Norfolk Boreas Offshore Wind Farm

Statement of Common Ground

Natural England

Applicant: Norfolk Boreas Limited
Document Reference: ExA.SoCG-17.D6.V3
Deadline: 6
Date: March 2020
Revision: Version 3
Author: Royal HaskoningDHV

Figure 1 *Sabellaria spinulosa* reef mapping by the Applicant and Natural England

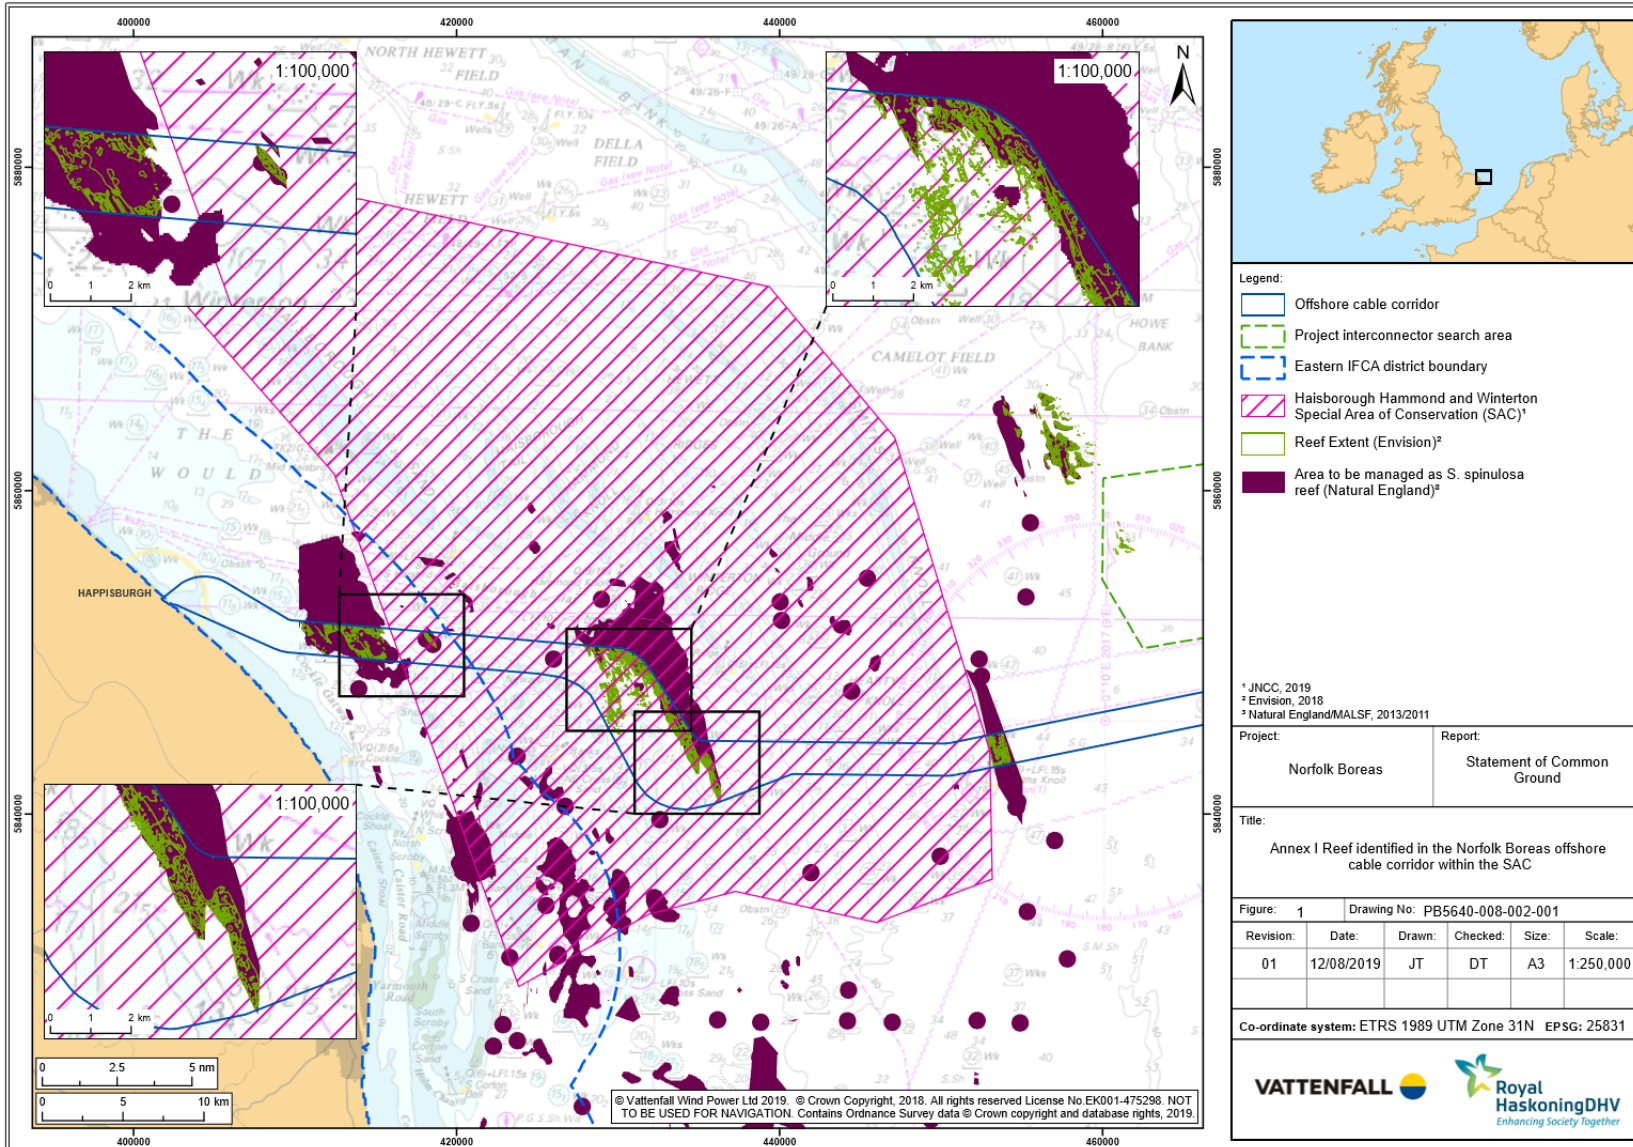
The approach to <i>S. spinulosa</i> reef mapping is appropriate to inform the EIA based on the data available.	Not agreed. Natural England has uncertainty associated with <i>S. spinulosa</i> reef mapping due to the ephemeral nature of the reef, the analytical use of a range of datasets, and the confidence levels applied to reef presence Appendix 2 (RR-099).	Area for ongoing discussion. (D2) Natural England are reviewing the

<p>The mapping of potential <i>S. spinulosa</i> reef by Envision on behalf of Norfolk Boreas (and Norfolk Vanguard Limited) identifies potential reef areas which are largely consistent with areas Natural England has identified (as shown on Figure 2.1 below).</p>	<p>Agreed</p>	<p>Agreed</p>
